Service Bulletin

Bulletin No.: PIT5351

Subject: Itch Squeak Type Noise From HUD Area

Models: 2015 Cadillac Escalade Models
2015 GMC Yukon Models
With Head-Up Display (RPO UV6)

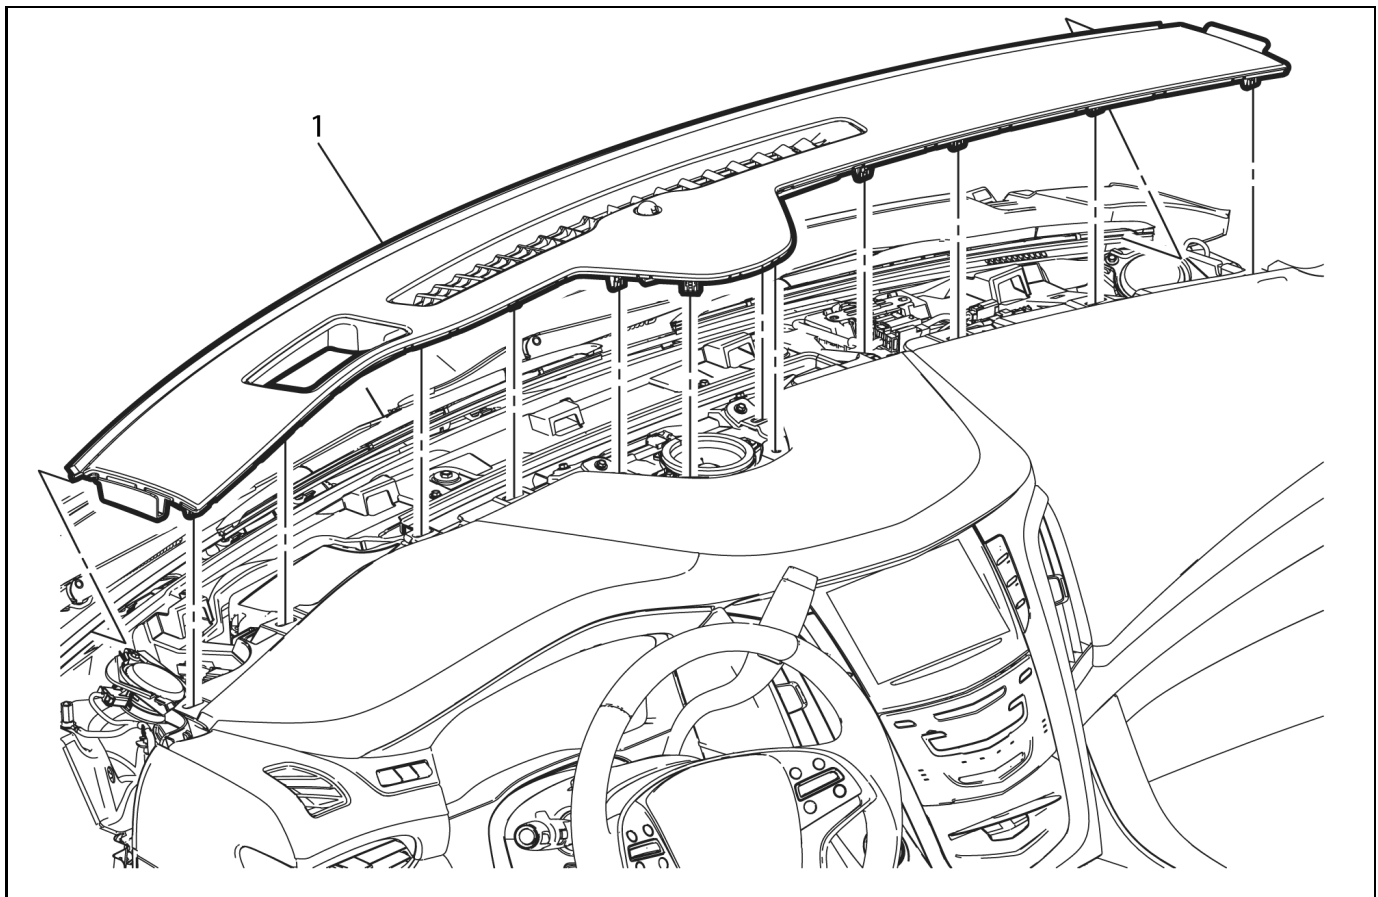
Some owners may comment of an itch or squeak type noise from the top left side of the dash while driving. This noise may also be duplicated while parked, if pressure is applied up and down on the steering wheel, not using the tilt. If, while trying to pin point the source of the noise, it may be reported that the issue can be felt coming from behind the cluster.

The noise could be caused by the Heads-Up Display (HUD) lense rubbing on the HUD shroud. The HUD shroud is part of the Upper Instrument Panel Extension, as shown below.
